To: SUPERSEDED BY EB 20-038 EFFECTIVE 9/3/20		<i>New York State Department of Transportation</i> ENGINEERING INSTRUCTION	EI 08-033
Title: TRANSITION TO THE NATIONAL MANUAL ON UNIFORM TRAFFIC CONTROL DEVICES			
Distribution: <input checked="" type="checkbox"/> Manufacturers (18) <input checked="" type="checkbox"/> Local Govt. (31) <input checked="" type="checkbox"/> Agencies (32)	<input checked="" type="checkbox"/> Surveyors (33) <input checked="" type="checkbox"/> Consultants (34) <input checked="" type="checkbox"/> Contractors (39) <input type="checkbox"/> _____ ()	Approved:  James F. Tynan, P.E. Deputy Chief Engineer (Construction)	9-3-08 Date

PURPOSE: To issue guidance for the transition of active projects let prior to 01/08/09 to the National Manual on Uniform Traffic Control Devices (NMUTCD)

Work Zone Modification depicts typical changed sign quantity and spacing. Sign quantity has been reduced. Some signs have different spacing. The use of work zone sign panels included in contract documents prior to the provisions of the Standard Sheets may be continued.

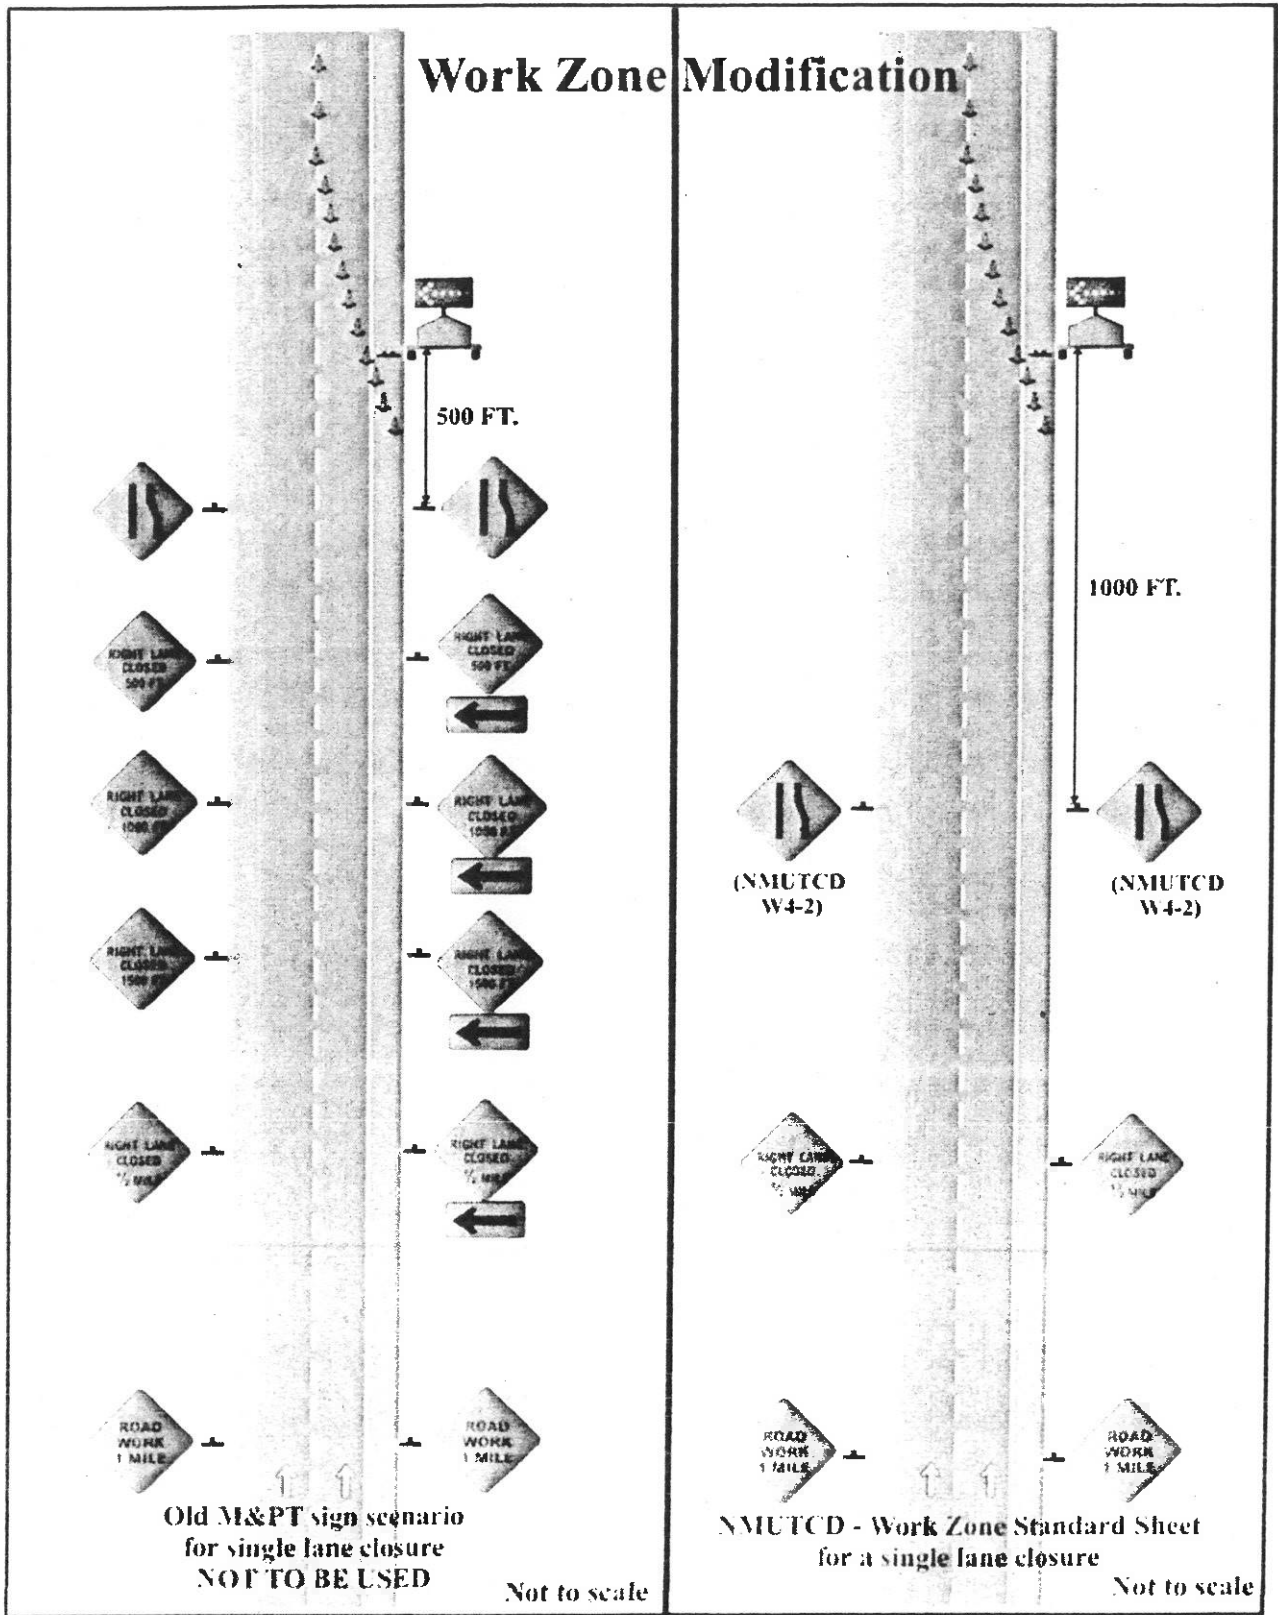
- The Standard Sheets may require changes to on-going contracts including work zone sign quantity and spacing. The attached exhibit entitled Work Zone Modification depicts typical changed sign quantity and spacing. Sign quantity has been reduced. Some signs have different spacing. The use of such work zone sign panels as *Lanes Ends* and *No Shoulder* included in contract documents prior to the provisions of the Standard Sheets may be continued. Sign quantity and spacing should comply with the Standard Sheets.
